UNITED STATES PATENT AND TRADEMARK OFFICE

APPLICATION NO.	FILING DATE	FIRST NAMED INVENTOR	ATTORNEY DOCKET NO.	CONFIRMATION NO.
09/639,684	08/15/2000	Dennis H. Runnoe	14374.14	4147

Office Action Summary

DETAILED ACTION

Figure 1 - U.S. Patent 5,264,801 to DeCou, Jr. et al.

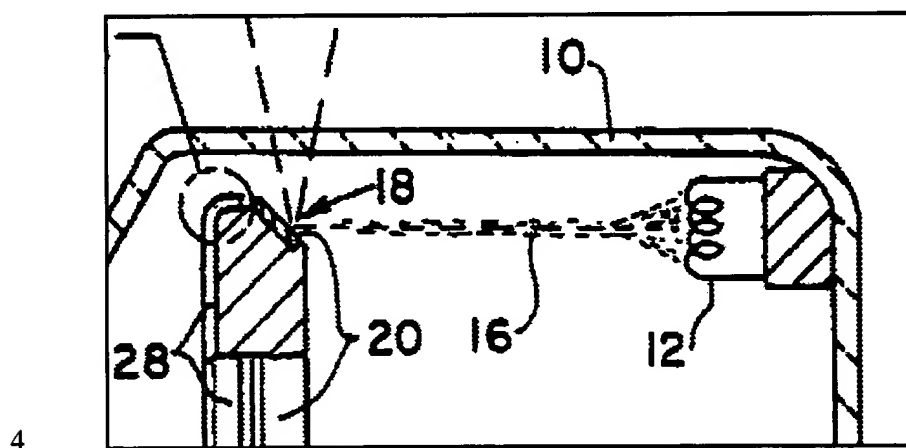
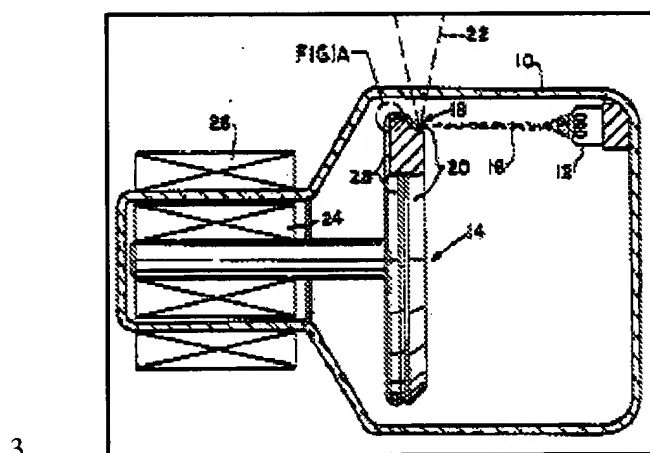
5. **As per claims 1, 5, 28, 29, 30, 44 and 53**, DeCou, Jr. et al. disclose an x-ray device, comprising:

6. (a) a vacuum enclosure (10),

7. (b) an integral cathode disposed in said vacuum enclosure (note: column 1, lines 14-15 and 17-19, column 2, lines 45-47) said integral cathode including an emitter (12) capable of discharging electrons (16), the emitter having a predetermined geometrical configuration oriented to cause some of the discharged electrons to converge to a focal spot (18);

8. (c) a power source (not shown above - however, DeCou Jr., et al. disclose the emission of electrons upon the application of DC potential - see also column 2, lines 61-65) connected to said emitter so that transmission of power from said power source to said emitter causes said emitter to discharge electrons;

9. (d) a target anode (14) disposed in said vacuum enclosure and having a target surface positioned to receive at least some of the electrons discharged by said emitter;

10. (e) a support cartridge, providing structural support for the emitter (see Fig. 1, above) and

11. (e) wherein the emitter (12) has a predetermined geometrical configuration oriented to cause at least some of the discharged electrons to converge to a focal spot (see Fig. 1, above; see also column 2, lines 61-65).

12. **As per claims 2 and 6**, DeCou, Jr. et al. disclose an x-ray device wherein the focal spot (18) is located proximate to the target surface of said target anode (14); (see Fig. 1 above).

14. As per claims 11-16, 18, 31-39, 41-43, 45-52 and 54-56 DeCou, Jr. et al. disclose an x-ray device wherein the support cartridge comprises at least one conductive portion, the electron beam and focal spot being selectively manipulated by the application of a voltage to the at least one conductive portion (i.e. Fig.1), the emitter comprises a plurality of subsidiary emitting portions integral with each other, at least two subsidiary emitting portions not being parallel to each other while cooperating to facilitate the convergence of at least some of the discharged electrons (see Fig. 1 above), wherein the at least two subsidiary portions are integral with each other and are disposed in a substantially "V" shaped configuration (see also Fig. 1 above); wherein a plurality of cut out portions are defined in the emitter, the plurality of cutout portions collectively defining an electrical current path; the emitter substantially comprises a single piece of emissive material, at least one of a subsidiary emitting portion is substantially planar, at least one of a subsidiary emitting portions substantially comprise a geometry selected from the group consisting of parabolic and spherical sections (see Fig. 1 above and respective portions of the specification).

Figure 2 - U.S. Patent 5,264,801 to DeCou, Jr. et al.

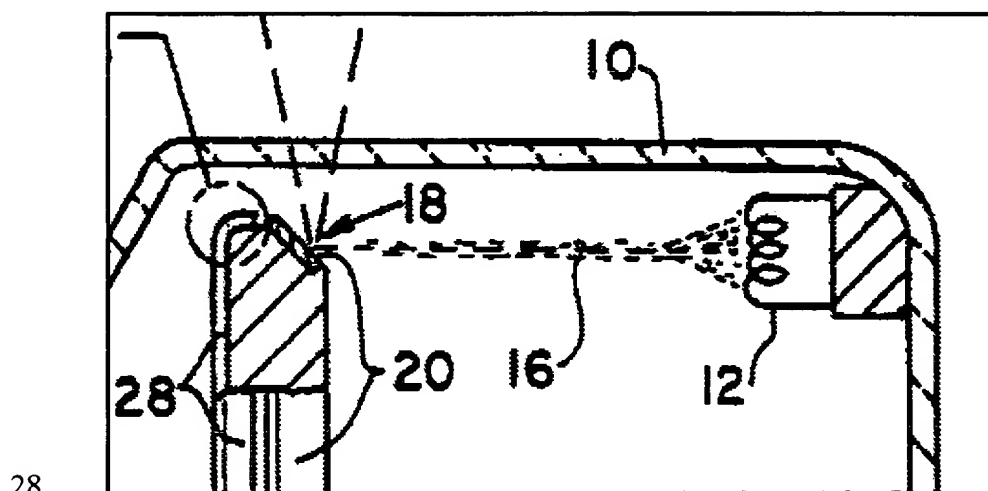
30. In particular, DeCou Jr., et al. (U.S. Patent 5,264,801) disclose an X-ray device comprising a vacuum enclosure (10), an integral cathode having an emitter (12), the emitter having a predetermined geometrical configuration oriented to cause at least some of the discharged electrons (16) to converge to a focal spot (18), a power supply (not shown above - DeCou Jr., et al. disclose the emission of electrons upon the application of DC potential - see

also column 2, lines 61-65), and a target anode (14) (Examiner notes that numeral 14 is not visible in the enlarged portion of Fig. 1 above) disposed in the vacuum enclosure (10) and having a target surface (20) positioned to receive at least some of the electrons (16) discharged by the emitter (12).

32. Examiner believes however, DeCou Jr., et al. (Patent '801) rightly meets the requirements for a 35 USC 102b rejection, since every element set forth in the claim is found, either expressly or inherently (compare claim language to DeCou Jr., et al. Fig. 1 above). Furthermore, Examiner has applied procedures commensurate with MPEP 2111 and 2111.01 during the examination of the current application and has concluded that the apparatus of DeCou Jr., et al. anticipates Applicants invention as claimed, including the limitation of an emitter having a predetermined geometrical configuration oriented to cause at least some of the discharged electrons to converge to a focal spot, since this feature is readily seen in Fig.1 of DeCou Jr. et al (see above).

33. Based on the above, Examiner concludes that Applicants arguments are not persuasive, since DeCou Jr. et al. meet every element set forth in the pending independent claims, including the limitation of an emitter having a predetermined geometrical configuration oriented to cause at least some of the discharged electrons to converge to a focal spot.
